Addendum-01

TENDER NO. MANPBT0029 EPC project for development of BESS at Kudgi & Simhadri

Addendum: 01 Date: 11.11.2025

Amendments - EPC PACKAGE FOR DEVELOPMENT OF BESS AT NTPC THERMAL POWER STATIONS (Lot-1)

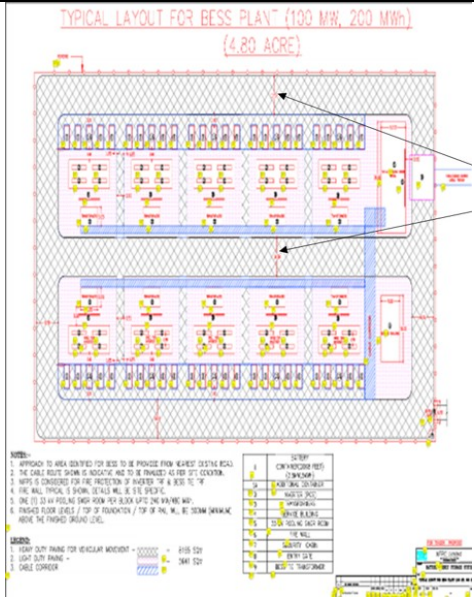
Bidder understands that the heavy-duty paving is RCC paving of 0.15m thick and reinforcement of 10mm diameter bar at 200mm c/c and the light duty paving shown in the Typical BESS layout in the Section E - Tender drawings is the normal duty paving of RCC paving of 0.15m thick and reinforcement of 8mm diameter bar at 200mm c/c. Kindly confirm.

As per the Typical layout for BESS, it is shown to provide 10.5 wide heavy duty paving area. Bidder proposes to provide internal road of Bitumen of 3 m wide carriage way and 0.5 m thick shoulder on both side as per Standard NTPC Specification instead of Heavy duty paving inside the BESS locations and PSS location due to space constraint. Kindly confirm.

Bidder proposes to provide Gravel filling of 0.15m thick instead of the light duty paving shown in Typical BESS layout. Kindly confirm.

ITEM	DESCRIPTION	UNIT	QUANTITY	REMARKS	1	CONCRETE PAVING	SQ. M	10000		2	CONCRETE PAVING	SQ. M	10000		3	CONCRETE PAVING	SQ. M	10000		4	CONCRETE PAVING	SQ. M	10000		5	CONCRETE PAVING	SQ. M	10000		6	CONCRETE PAVING	SQ. M	10000		7	CONCRETE PAVING	SQ. M	10000		8	CONCRETE PAVING	SQ. M	10000		9	CONCRETE PAVING	SQ. M	10000		10	CONCRETE PAVING	SQ. M	10000		<p>As per the Typical layout for BESS, it is shown to provide 10.5 wide heavy duty paving area. Bidder proposes to provide internal road of Bitumen of 3 m wide carriage way and 0.5 m thick shoulder on both side as per Standard NTPC Specification instead of Heavy-duty paving inside the BESS locations and PSS location due to space constraint. Kindly confirm.</p>	<p>Bidder's proposal is not acceptable, and the bidder shall comply with the technical specifications.</p>
ITEM	DESCRIPTION	UNIT	QUANTITY	REMARKS																																																					
1	CONCRETE PAVING	SQ. M	10000																																																						
2	CONCRETE PAVING	SQ. M	10000																																																						
3	CONCRETE PAVING	SQ. M	10000																																																						
4	CONCRETE PAVING	SQ. M	10000																																																						
5	CONCRETE PAVING	SQ. M	10000																																																						
6	CONCRETE PAVING	SQ. M	10000																																																						
7	CONCRETE PAVING	SQ. M	10000																																																						
8	CONCRETE PAVING	SQ. M	10000																																																						
9	CONCRETE PAVING	SQ. M	10000																																																						
10	CONCRETE PAVING	SQ. M	10000																																																						
	<p>Bidder proposes to provide Gravel filling of 0.15m thick instead of the light duty paving shown in Typical BESS layout. Kindly confirm.</p>	<p>Bidder's proposal is not acceptable, and the bidder shall comply with the technical specifications.</p>

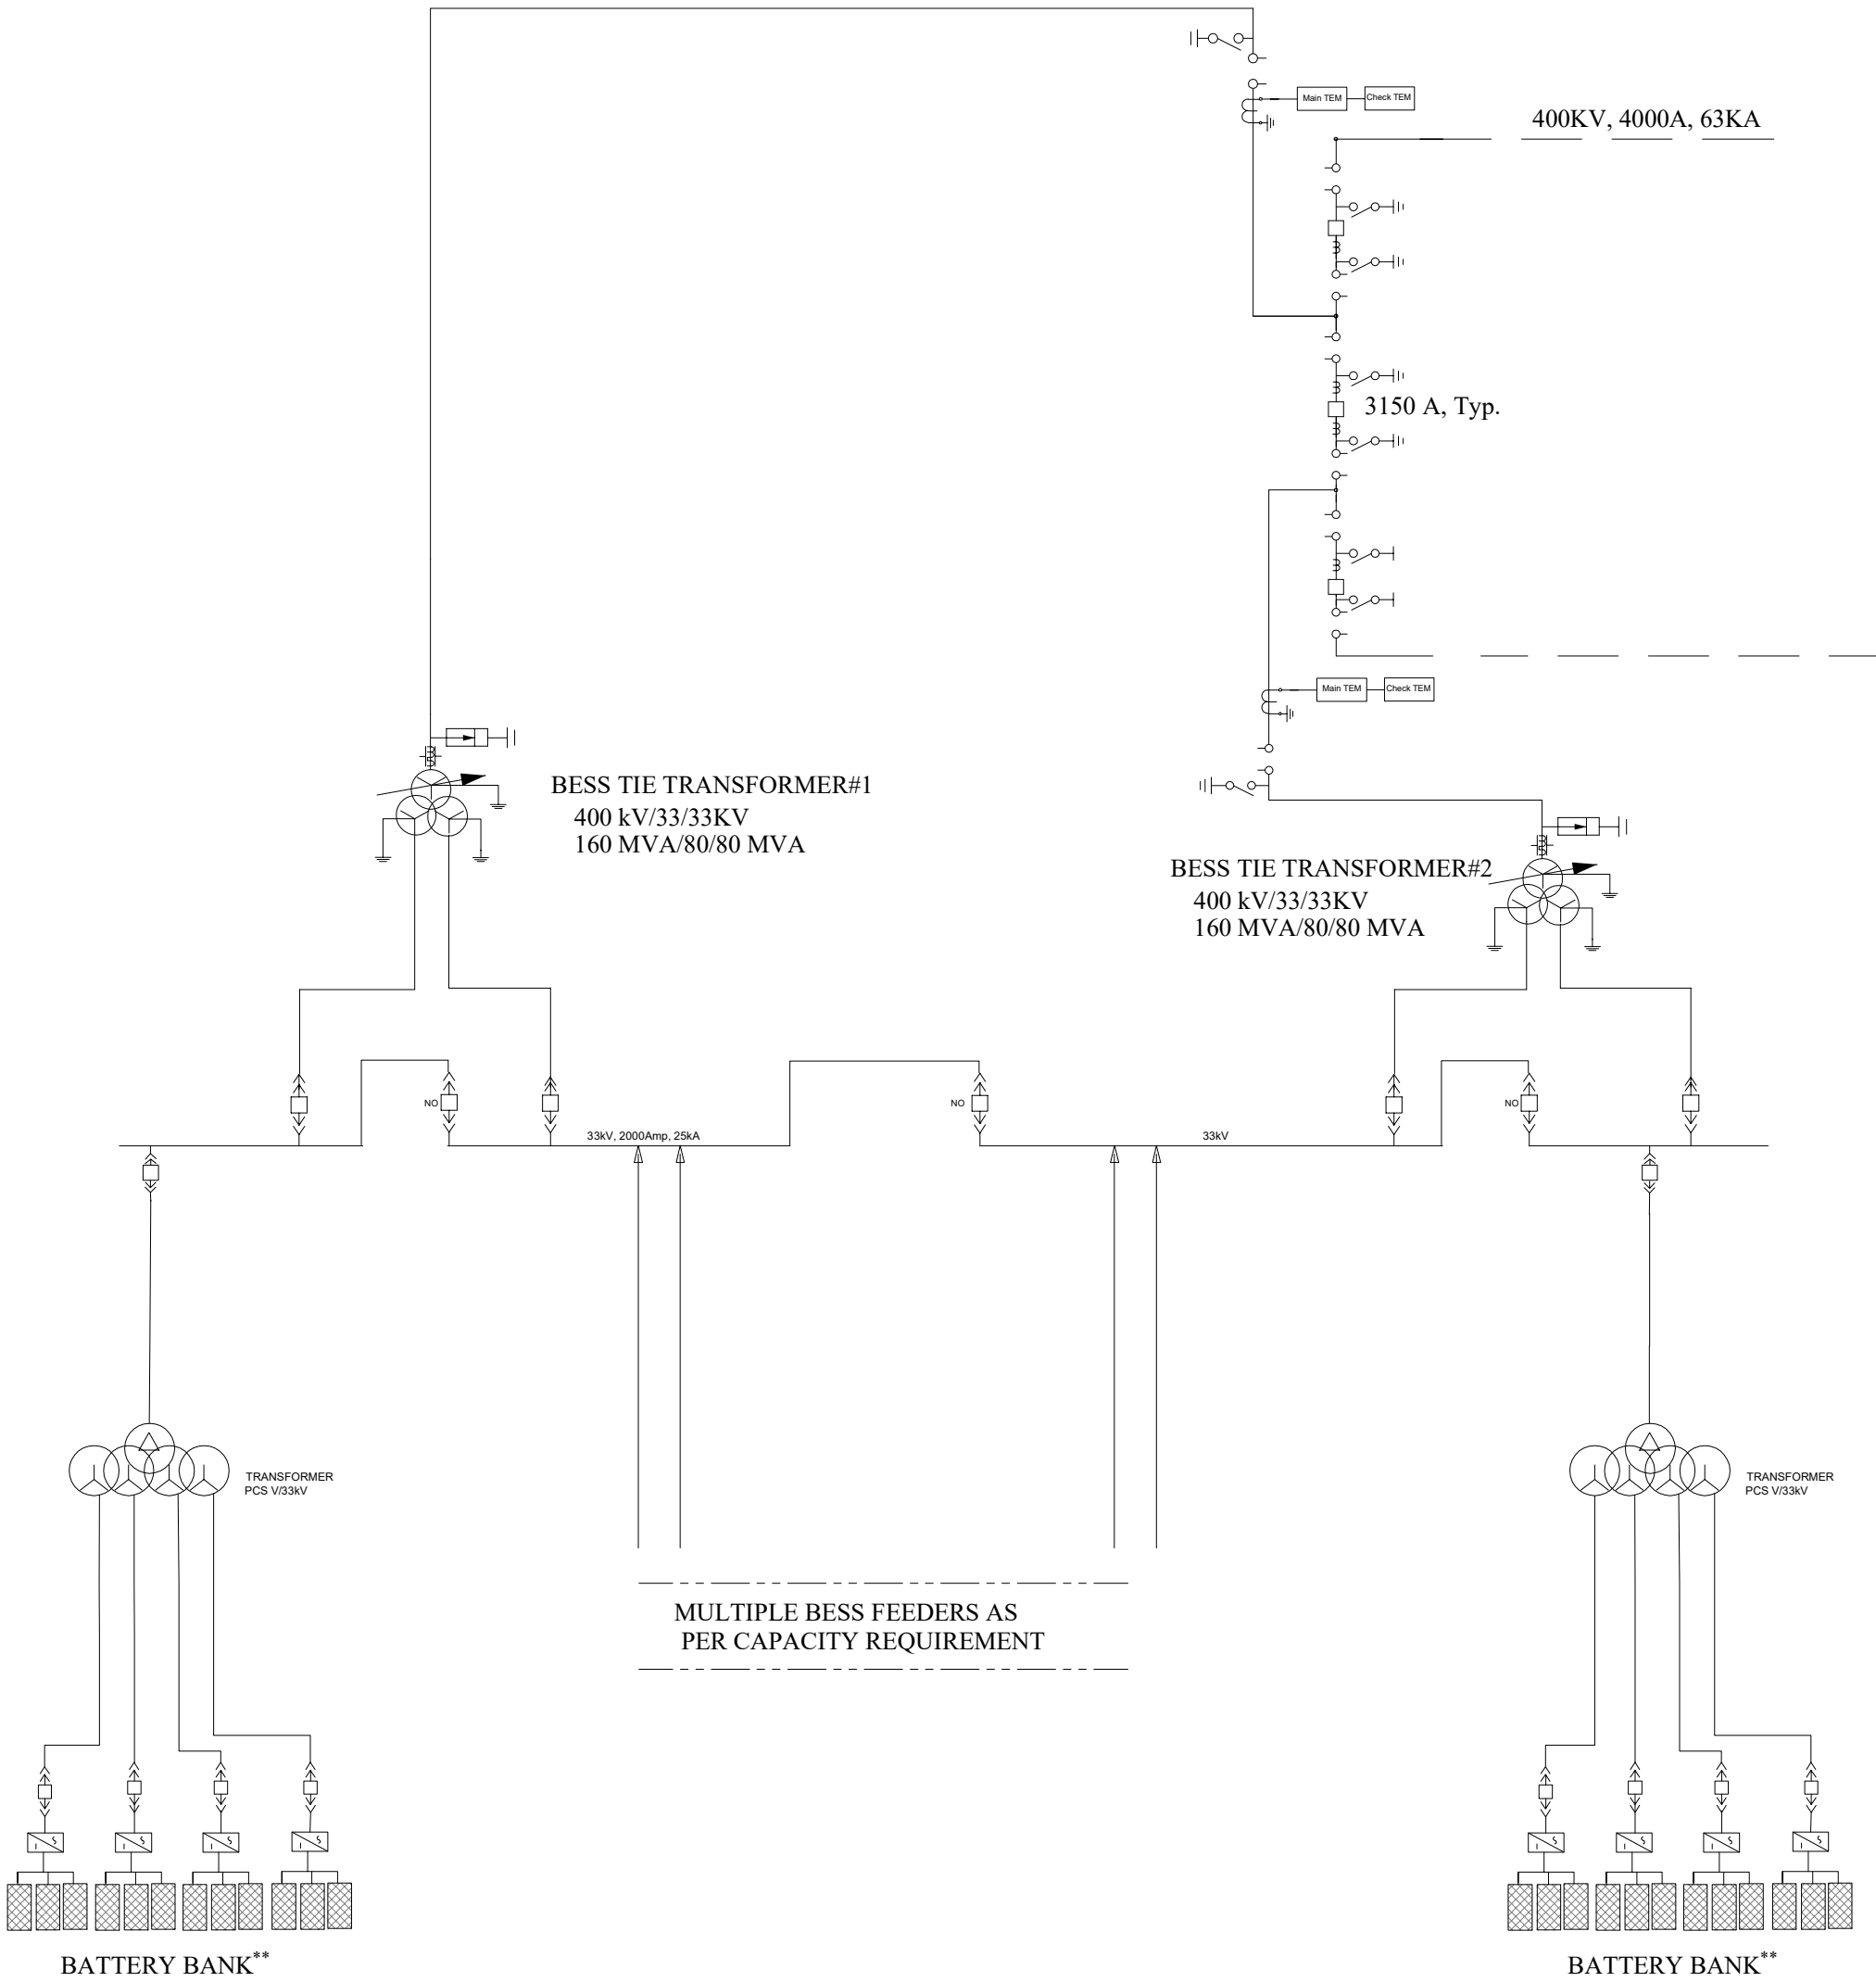
EXISTING SPECIFICATION		TO BE READ AS	
Tender SLD Rev B		Tender SLD Rev C as Annexure 1	
b) Tie Transformer and it's components (OLTC, Bushing, etc) shall be designed for 110% over load condition continuously without exceeding temperature rise limits as specified above, also Tie Transformer shall be designed for overloading as per IEC 60076 without any adverse impact on the transformer. Transformer Name plate shall mention Transformer MVA rating corresponding to 110% rating of Transformer.		b) Tie Transformer and it's components shall be designed for cyclic loading, continuous loading and over load condition as per IEC 60076 without any adverse impact on the transformer.	
Project	Bay details for Point of interconnection	Project	Bay details for Point of interconnection
Kudgi 240x 2 Hrs 2 Bays	Existing 220 kV bay no 8 & 9 Main Bus bar available. Only bay equipments are to be provided.	Kudgi 240x 2 Hrs 3 Bays	400 kV bay no 30, 31 & 32 Main Bus bar available. Bay equipment to be provided.
